**Public Information Meeting Notes**  
**January 19, 2021**  
**File 19-15 A**  
**Meadows Development**

## Questions from Lee Chalmers (Falmouth resident) in response to proposed Development Agreement for the Meadows Phase 2 Development

**Todd Richard, Director of Public Works, Response to Lee Chambers Questions on February 23, 2021**

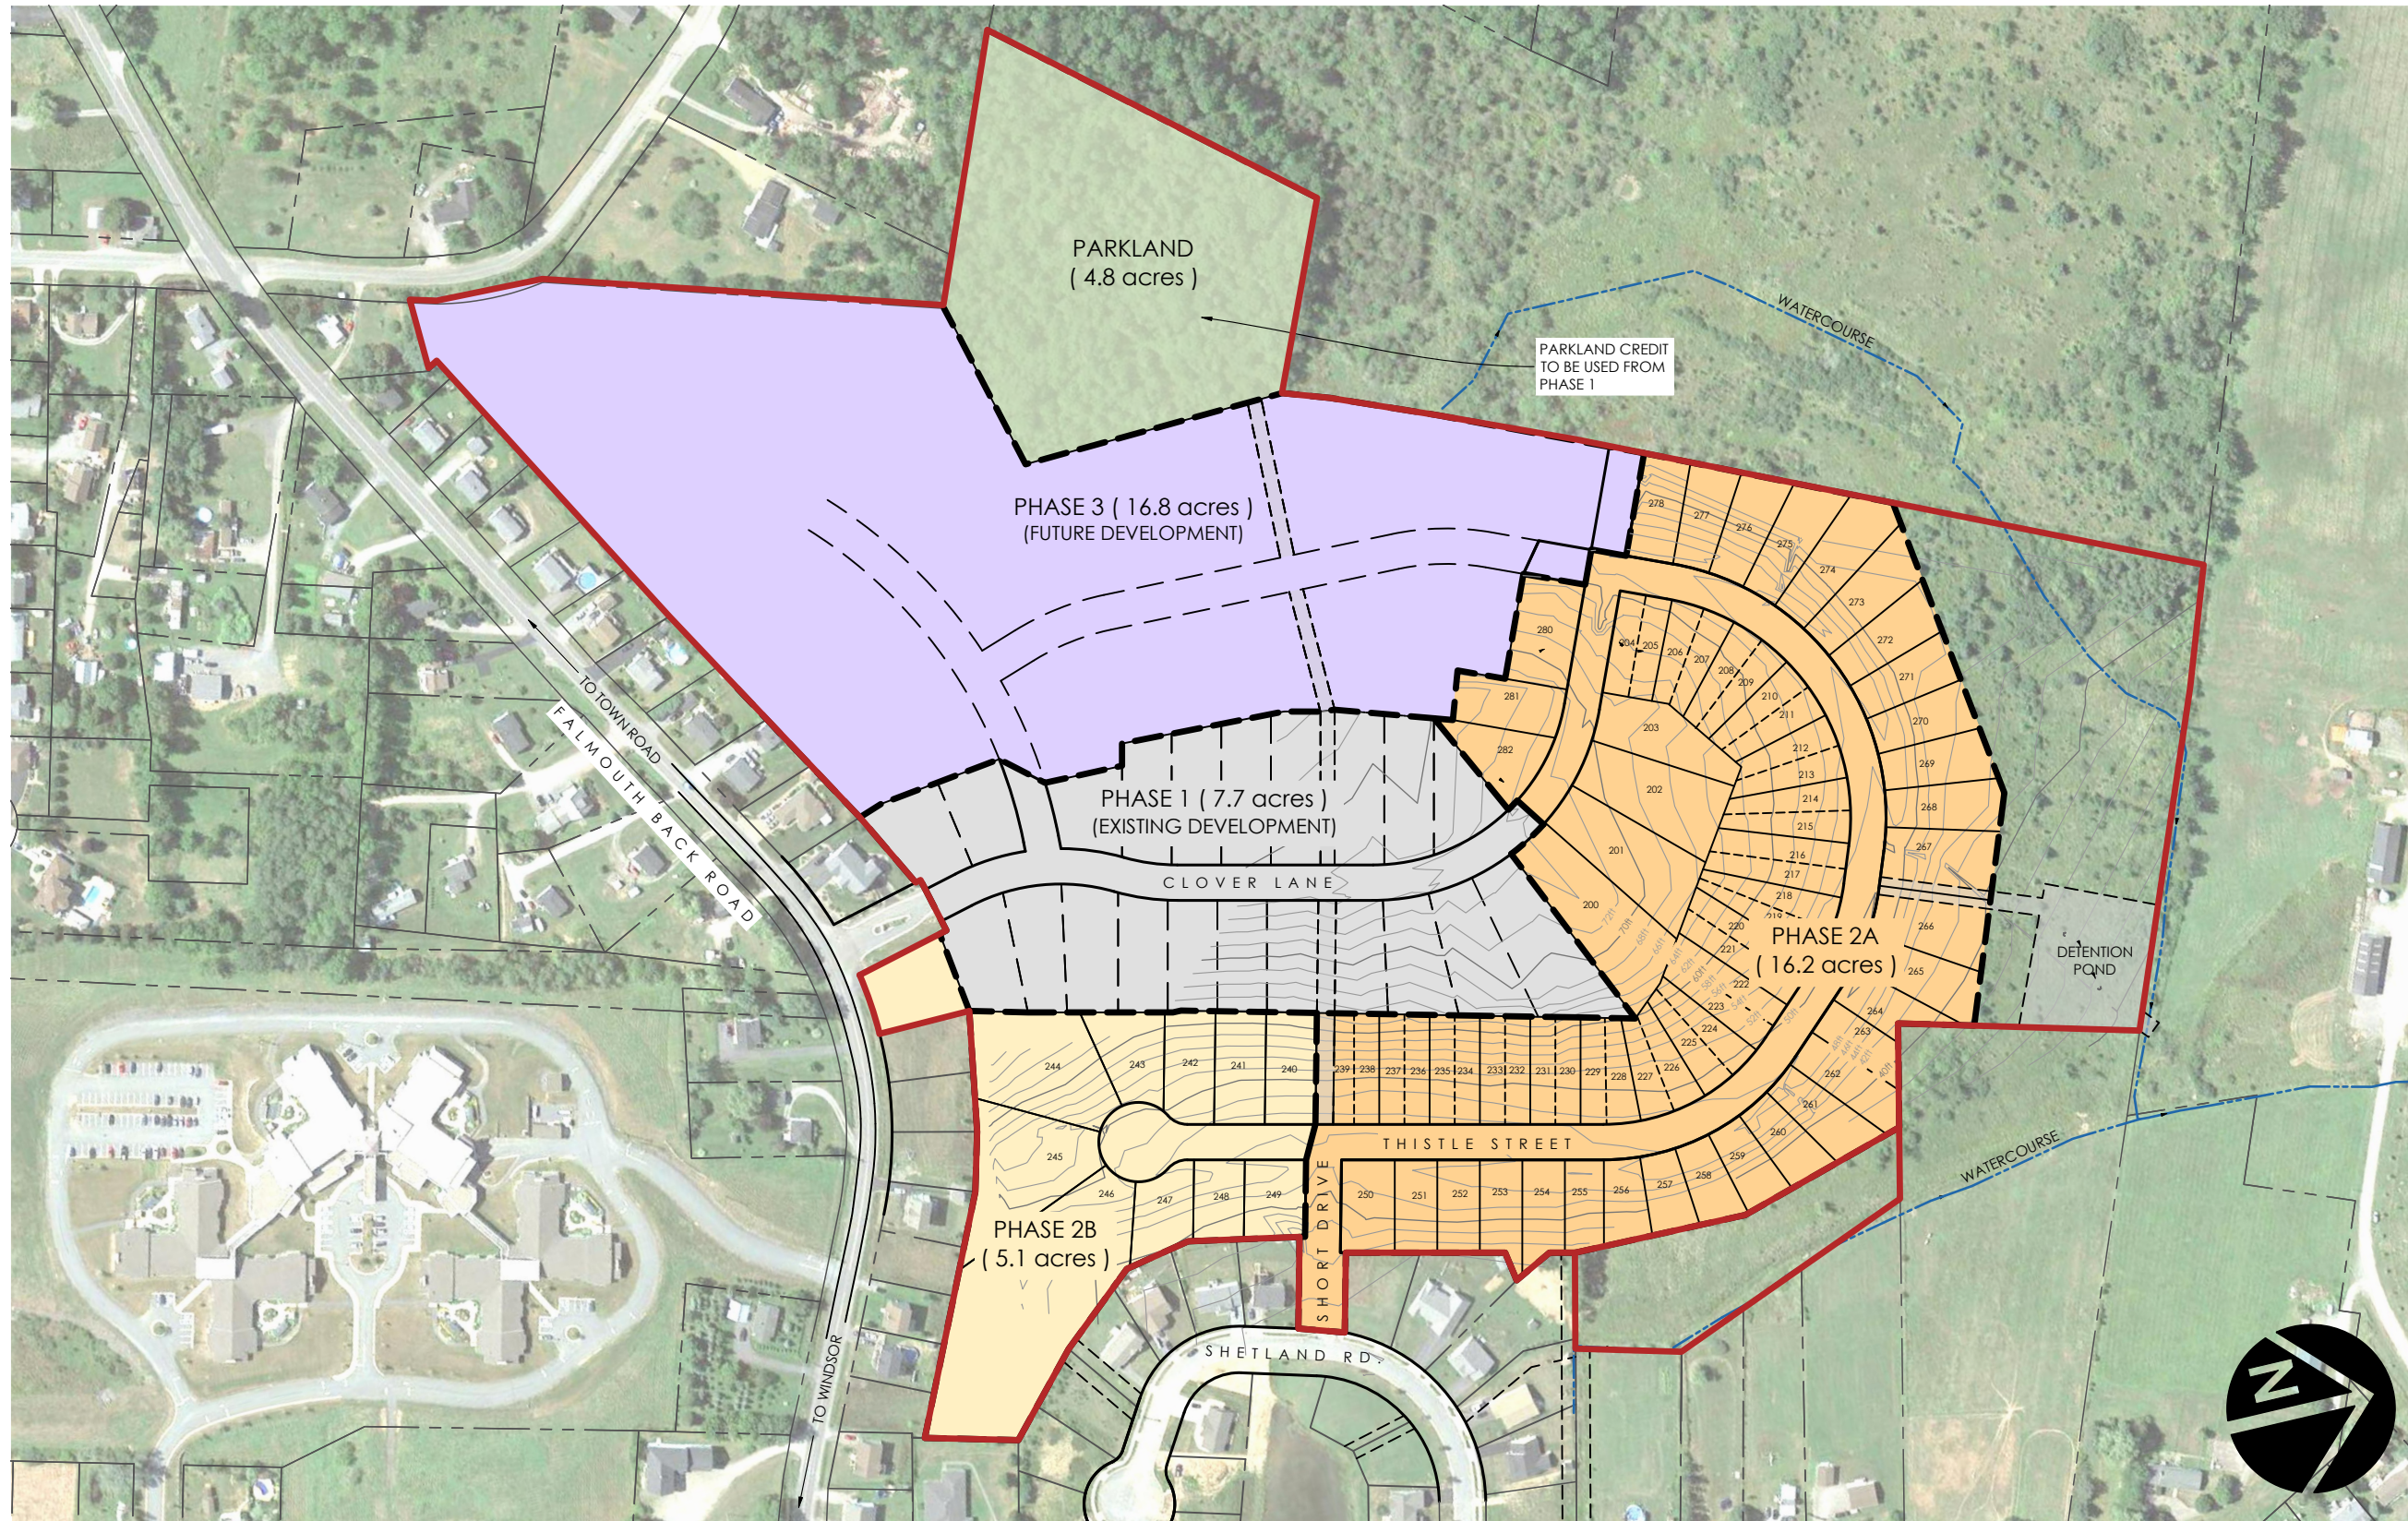
Unfortunately, the site plan presented pertained only to single and two-unit residential development. No information has been provided to date about what is being proposed in terms of three- and four-unit residential development on the Meadows site or the overall configuration of 1-4 unit housing. Without these details, it is difficult to comment on the merits of the proposal, for the number of possible dwelling units, by my count, could range from 83 (as proposed by the ZZap site plan<sup>1</sup>) to 130 (perhaps higher).<sup>2</sup>

<sup>1</sup> ZZap Site Plan: The Meadows, Version 104 (June 8, 2020). While the unit summary in the ZZap site plan identifies 10 R1 units as part of Phase 2B, the site map identifies 11 units, suggesting a total of 83. The lot on the corner of Falmouth Back Road and Clover Lane may account for the discrepancy. A copy of the site plan has been appended for convenience.

1. Can a site plan that details the total number of dwelling units and the intended mix of 1/2/3/4-unit housing for Phase 2 of the Meadows development (and as generally described in Policy 5.4.4(i) of the Municipal Planning Strategy) be provided to the public for comments/questions (as part of this public engagement process)?
